SUBJECT: NuScale Power, LLC Response to NRC Request for Additional Information No. 270 (eRAI No. 9185) on the NuScale Design Certification Application

NuScale Response to NRC Request for Additional Information eRAI No. 9185

NRC Question No.: 02.03.04-1

Figure 2.3-2: Source to Control Building Door Distances

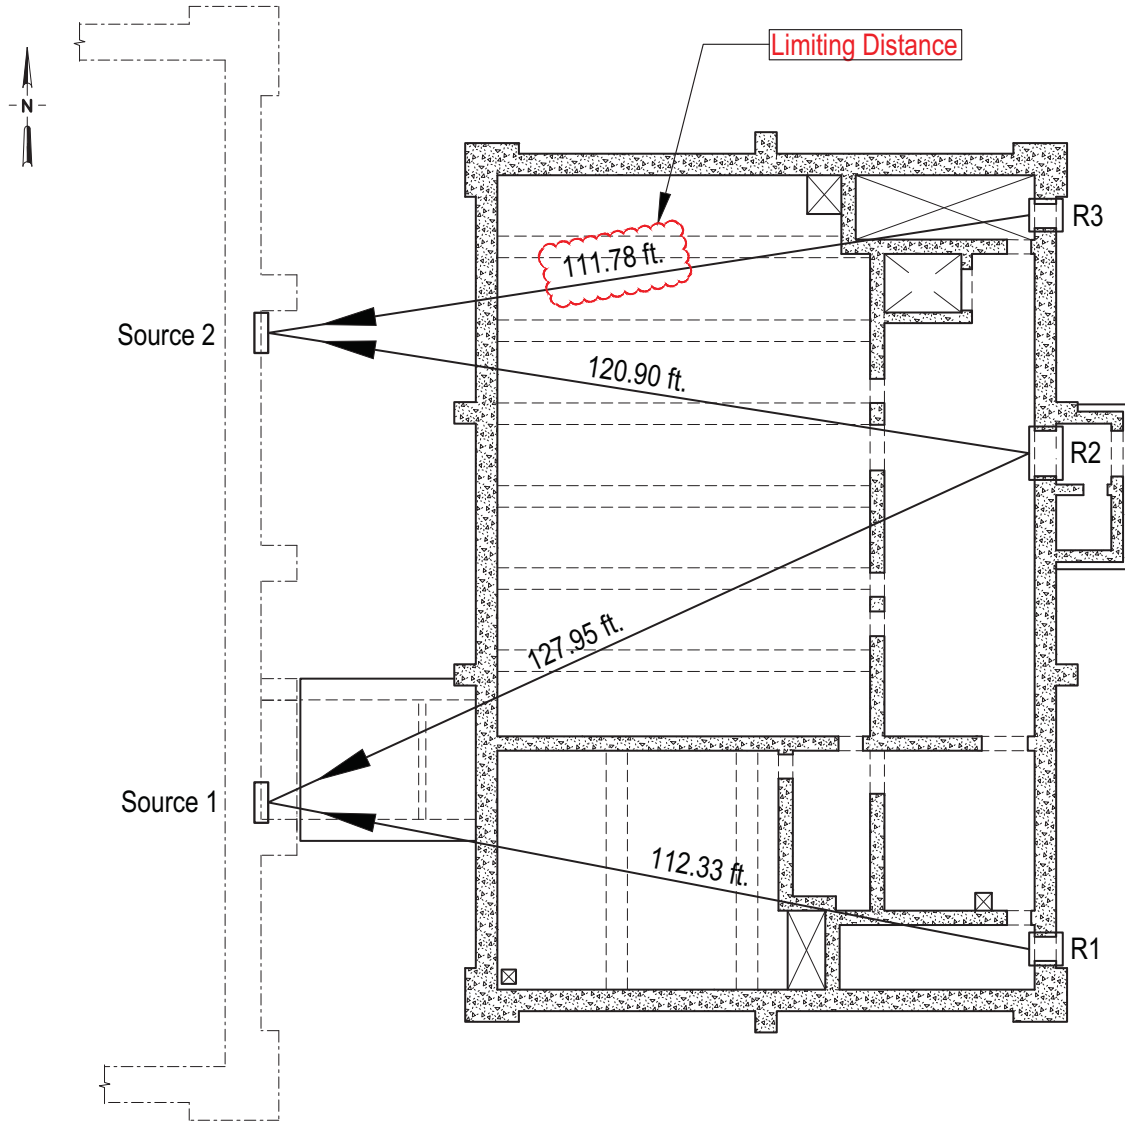
- a. Please revise the DCA FSAR to include all the NuScale nuclear plant configuration data required by COL applicants to perform atmospheric dispersion modeling (e.g., release heights, intake heights, building area).
- b. Please revise the directions shown in NuScale DCA FSAR Tier 2, Figures 2.3-2 and 2.3-3 from "source to receptor" directions to "receptor to source" directions.
- c. Please provide the basis that supports NuScale's position that the two source locations shown in NuScale DCA FSAR Tier 2, Figures 2.3-2 and 2.3-3 (e.g., the reactor building SE and NE single personnel doors) are the limiting source locations for all radiological accidents evaluated in the NuScale DCA FSAR.

b. FSAR Tier 2, Figures 2.3-2 and 2.3-3 are revised as requested, as shown in the attached markup. Note that the degrees are no longer shown. This is because the degree input to NARCON is based on the angle between the source and the receptor in relation to the true north which the weather data is based on. Since the layout of the buildings in the FSAR are in relation to an arbitrary "site north" which may or may not align with the as constructed plant's orientation to true north, this NARCON input can not be generically stated and the COL applicant will have to establish the correct input to NARCON if they have to redo the control room dose analysis.

c. The two source locations shown in Figures 2.3-2 and 2.3-3 are the limiting source locations because they are the closest source locations to the main control room personnel doors and main control room HVAC intake. FSAR Tier 2, Section 2.3.4 has been updated as shown in the attached markup to clarify this.
